Project CHATHAM WATERFRONT
RIBA STAGE4

Title LANDSCAPE PLANTING PLAN
BLOCK C, 2 of 2
ADJACENT PLINTH RAMP

RAAMP Drawing / Figure Number Rev
18.037-RAAMP-V1-00-DR-L-0077-S3-P5

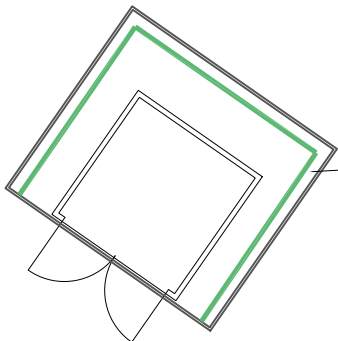
Replaced back to P3 planting type,
omitted Parthenocissus quinquefolia

CLIMBER
8no. Trachelospermum jasminoides
